**Minutes of the North Carolina Building Code Council**  
**March 8<sup>th</sup>, 2011**  
**Raleigh, NC**

**Part A - Administrative Items**

**FIGURE R403.3 (1)  
CONCRETE AND MASONRY FOUNDATION DETAILS**

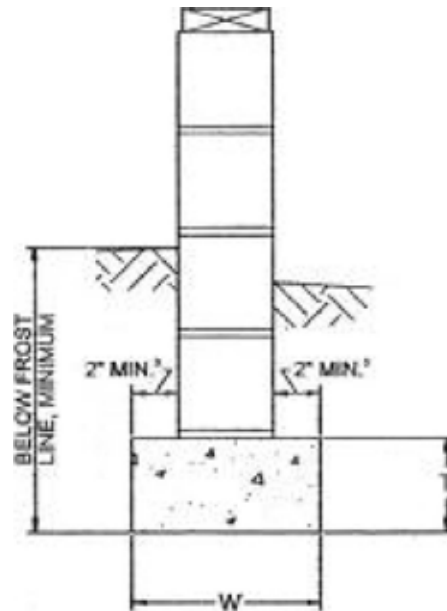
**Item C-20 Request by Robert Privott representing NC Home Builders Associations and Governor Beverly Perdue to amend the 2012 NC Residential Code, Table R403.3(1). The proposed amendment is as follows:**

1. Foundations shall extend not less than 12 inches below ~~the natural grade or engineered fill~~ finished grade and in no case less than the frost line depth.  
REMAINING NOTES TO REMAIN THE SAME
